Our Case Number: ABP-314724-22

Re: Railway (Metrolink - Estuary to Charlemont via Dublin Airport) Order [2022]
Metrolink. Estuary through Swords, Dublin Airport, Ballymun, Glasnevin and City Centre to Charlemont, Co. Dublin

Our Ref: 2193 General Submission

Re: Railway (Metrolink–Estuary to Charlemont via Dublin Airport) Order 2022

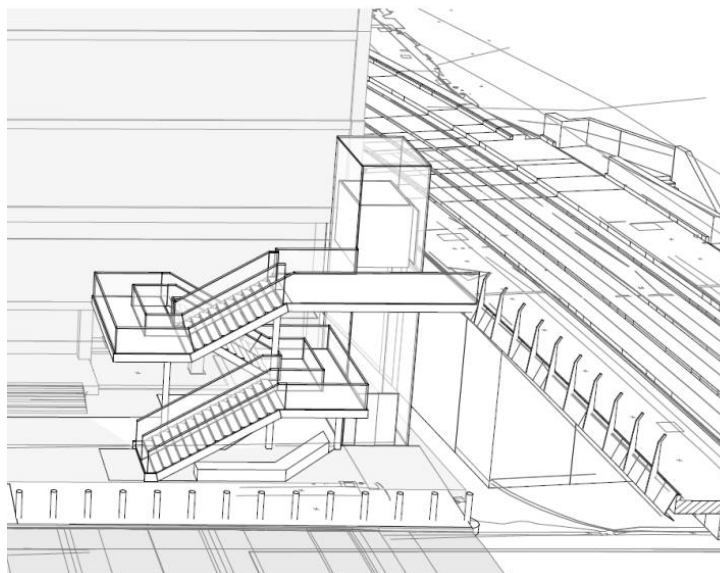
We have reviewed and are fully supportive of the Metro South West submissions to An Bord Pleanála. The logic of their submissions is inescapable. The South West of the City is the zone that is in most need of fixed rail, as it is the area that does not, or will not, benefit from high quality public transport before 2042. The South East of Dublin is well served by DART and the Luas Green Line. The West is served by the Luas Red Line. It is evident that there is a significant gap between the Red and Green Lines in the Rathmines, Kimmage, Rathfarnham, Terenure and Knocklyon areas.

The *Greater Dublin Area Transport Strategy 2022-2042* indicates Luas extensions to Knocklyon and Kimmage post 2042. However, the amended application has prejudiced the potential to provide quality public transport in the form of Metro to serve important areas such as Portobello and Rathmines, as an alignment terminating at Charlemont will not be capable of serving these areas. The Metro South West submissions highlight that Bus Connects will be incapable of serving the needs of this portion of the City.

The amended Application has persisted with bringing MetroLink to Charlemont / Ranelagh, thereby duplicating the Green Line from Saint Stephens Green at a cost, estimated by the Applicant, at €650m. The Applicant has provided no economic analysis to justify favouring Charlemont over Portobello/Rathmines.

A Metro which terminates at St. Stephens Green will however facilitate such an onward extension to the Rathmines, Portobello area and beyond to the Southwest. The applicant's submissions at the Oral Hearing provides no evidence which indicated that the current alignment would facilitate the appropriate onward extension to the Southwest. It is our interpretation that it would be impractical to do so.
